City of Madison, Wisconsin

REPORT OF: FAÇADE IMPROVEMENT GRANT STAFF TEAM

TO: URBAN DESIGN COMMISSION

Façade Improvement Grant Application:
1: 101 King Street

101 King

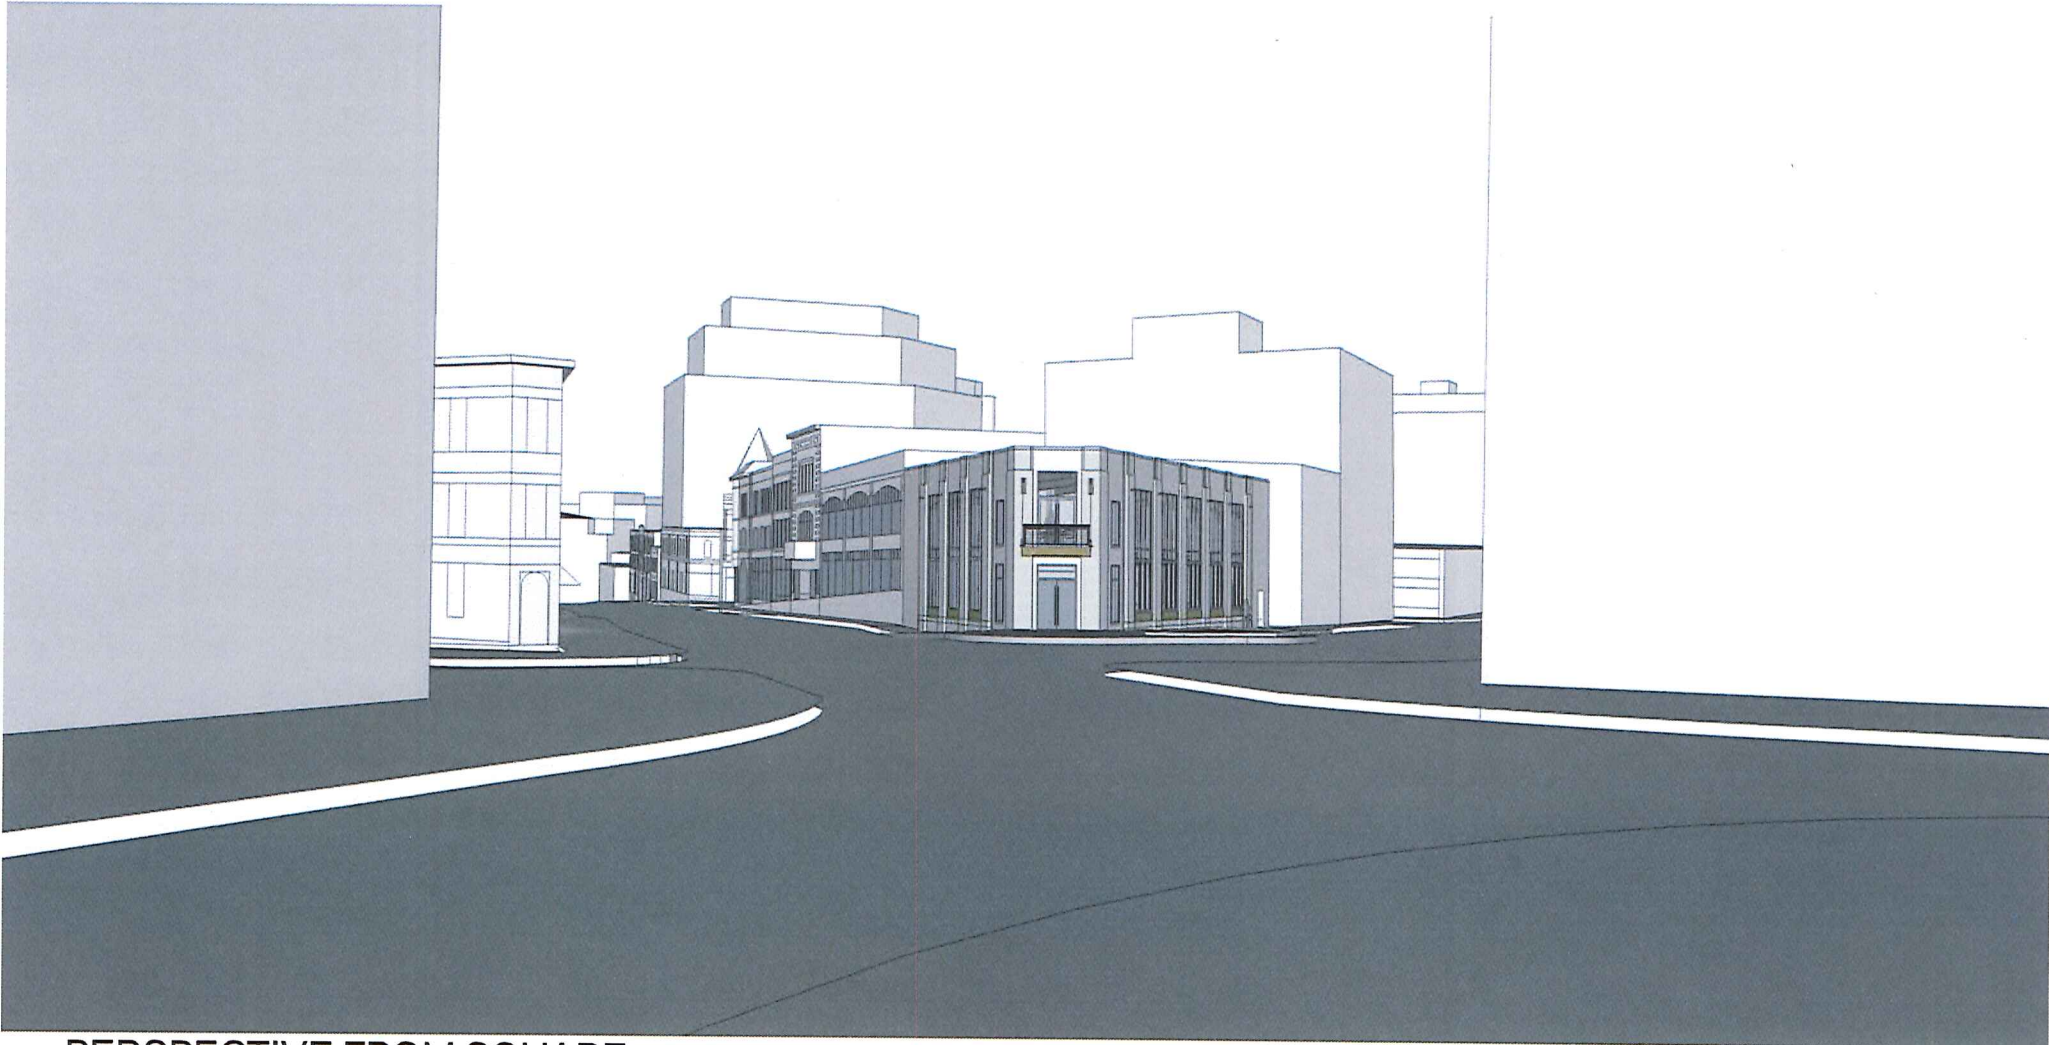
Favorable consideration of this project by the Urban Design Commission must be accompanied by findings that it satisfies the Planned Development District Standards in that the exterior architectural modifications are appropriate. The extension of the corner balcony would have required approval as an encroachment; recent plan revisions provide that it is no longer in the public right-of-way. If considered favorably, the balcony should be designed to be more compatible with the building’s architecture and not appear “tacked” on as well as the use of wood materials as part of the material palette in a primarily masonry building. Staff doesn’t believe that the balcony as designed and wood entry doors and trim mesh with the building’s architectural context as well as adjacent structures, both of which require scrutiny and are not consistent with the Downtown Urban Design Guidelines as

referenced. A design that complements the building's current and past "end iron façade" and that integrates the balcony element may act to enhance the building's flat iron façade, along with use of other materials aside from wood doors and trim.
